A G E N D A
FARRAGUT MUNICIPAL PLANNING COMMISSION

December 17, 2015
7:00 p.m. Farragut Town Hall

**SUBJECT: STAFF COMMENTS ON A SITE PLAN FOR FAÇADE MODIFICATIONS AT
SUMMIT VIEW OF FARARGUT, 12823 KINGSTON PIKE**

SUBJECT: STAFF COMMENTS ON A SITE PLAN FOR A CANOPY ADDITION AT THE SEASONS RESTAURANT AT 11605 PARKSIDE DRIVE

Amenity Area - Pavilion Architecture

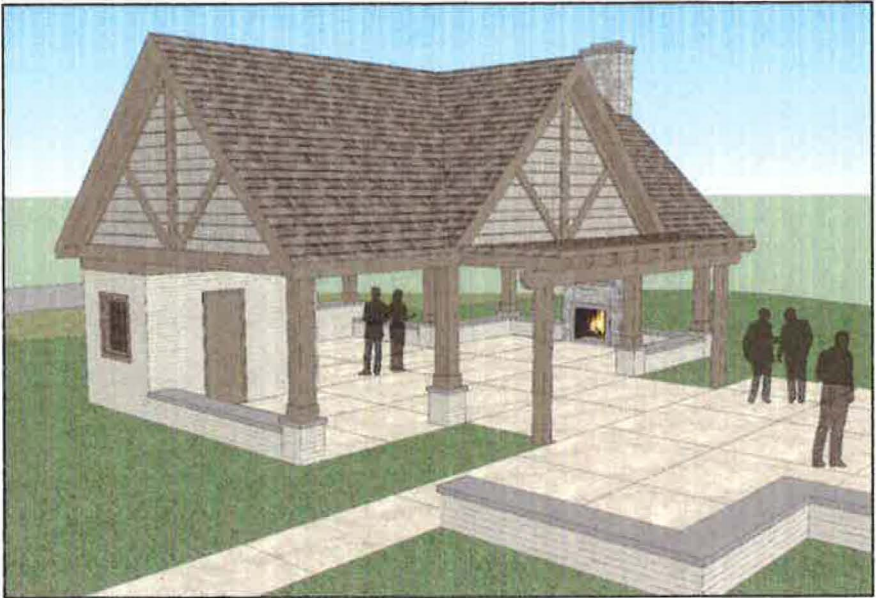
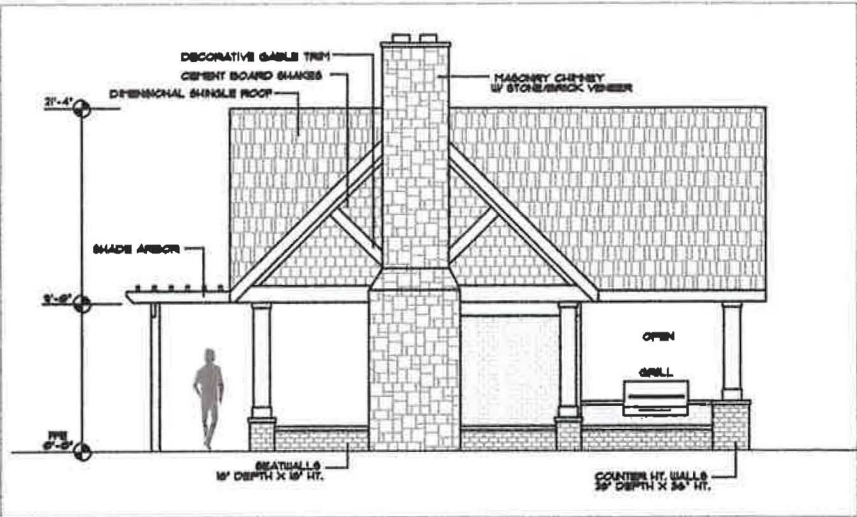
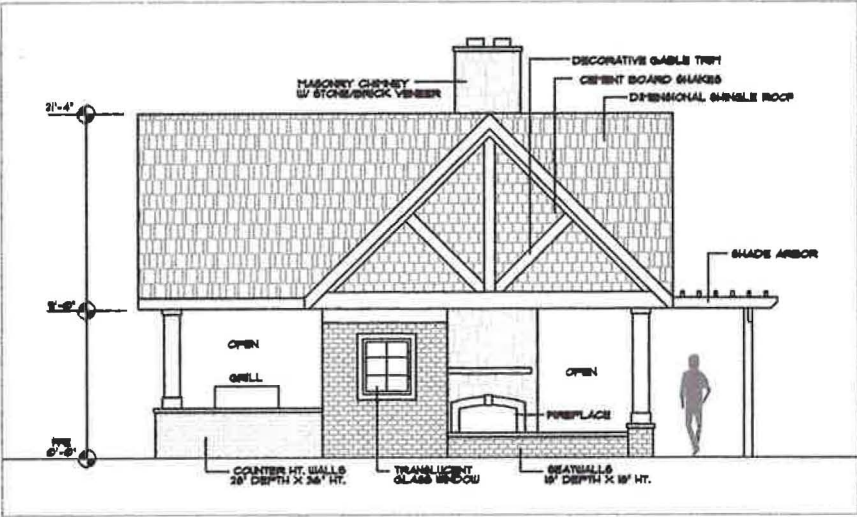
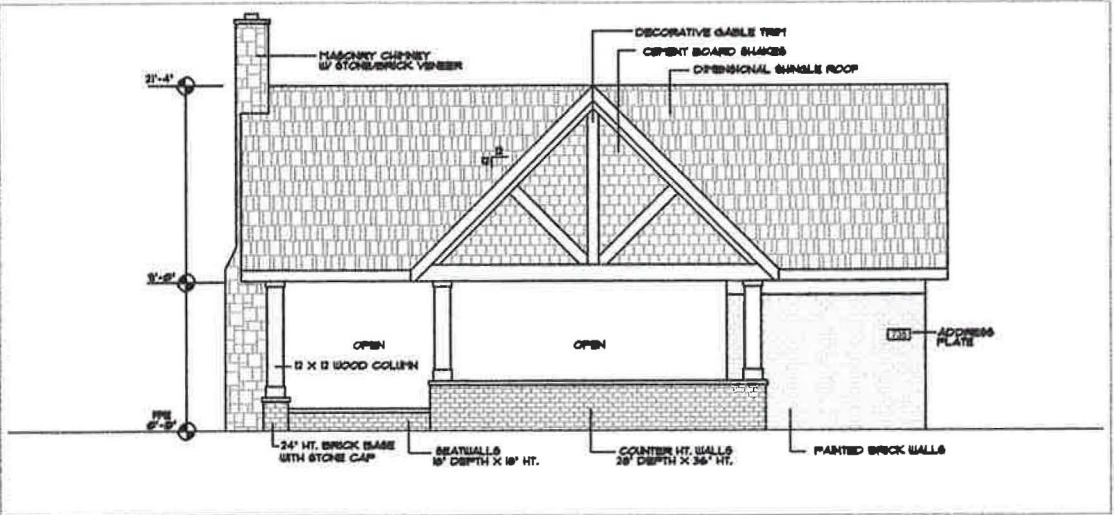
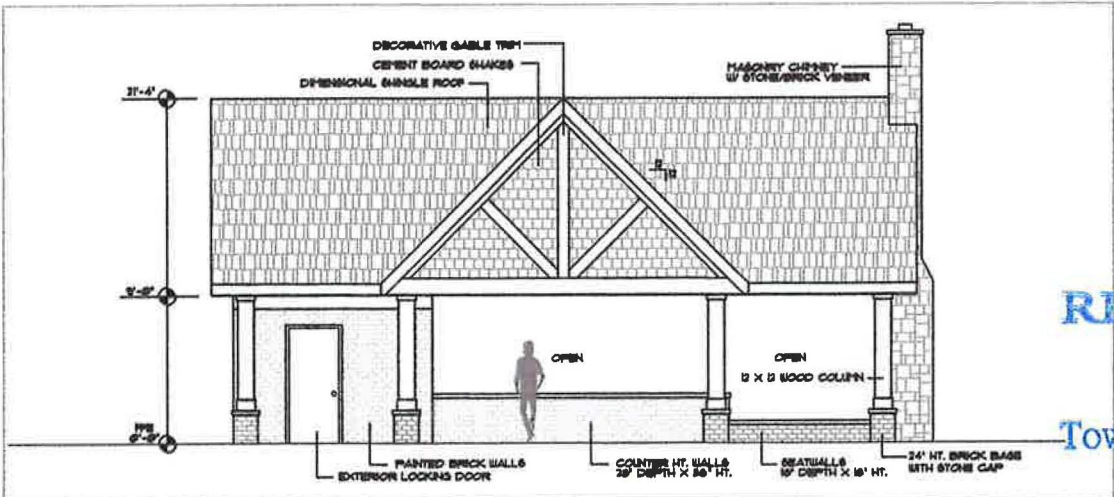
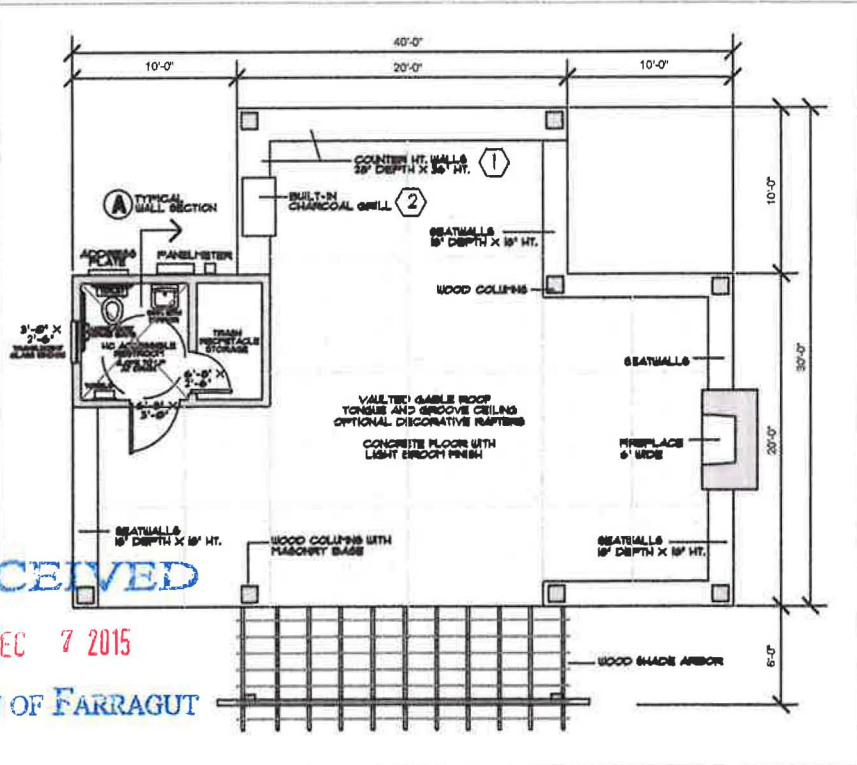
1. Please provide construction type;

8. On the lighting plan, please ensure the labeling associated with a specific light source on the electrical plan match the labeling on the lighting details;

9. Please express light measurement in lumens rather than wattage. Please verify that the lantern wall light will not exceed a total delivered lumens from the fixture of 950 lumens;

10. Please provide clarification as to which type of lenses will be used for the lantern style fixture. Any non-horizontal material that allows light through must be frosted or refractive with regard to light distribution. Clear non-horizontal lenses are prohibited;

11. Please provide clarification as to which type of lenses will be used for Pole P2 fixture. It needs to be clear that no portion of the bulb or material surrounding the bulb which allows light through protrudes from the light box/housing;
12. Please show the sidewalk along the road frontage and a proposed pedestrian connection to the sidewalk; and
13. Please submit a landscaping LOC based on the approved landscape plan that will be going to the VRRB on December 1.
